Hydro-electric power development at the Victoria Falls on the Zambesi River

D. D. A. PIESOLD, B. C. WALKER & G. B. MURDOCH

DISCUSSION

Fig. 15. Power house at base of gorge

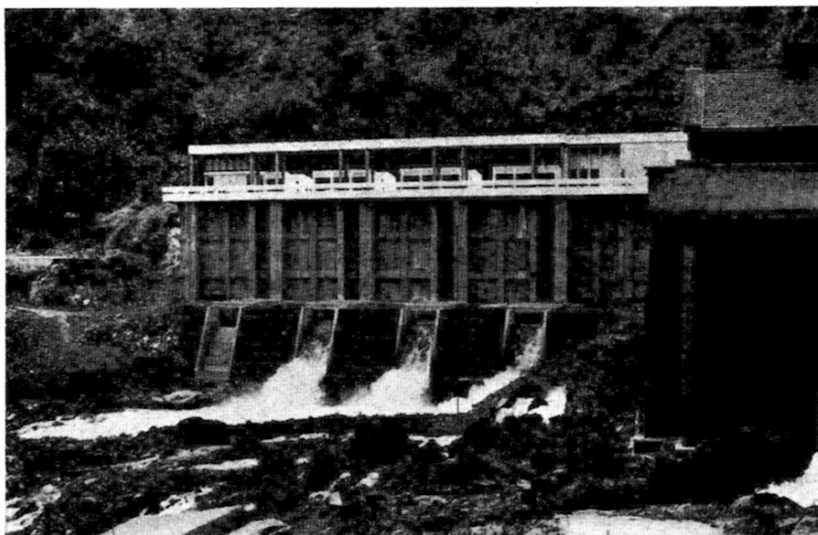
139. Figure 15 was taken at the base of the gorge when the river was low. It shows how, with practically no adjustment for aesthetic reasons, the engineering forms give clear expression to the four generating sets and one maintenance bay all below flood level. The gantry supports are related to the main vertical lines of the turbine hall formed by the columns, which also guide the bulkhead gates to the turbine
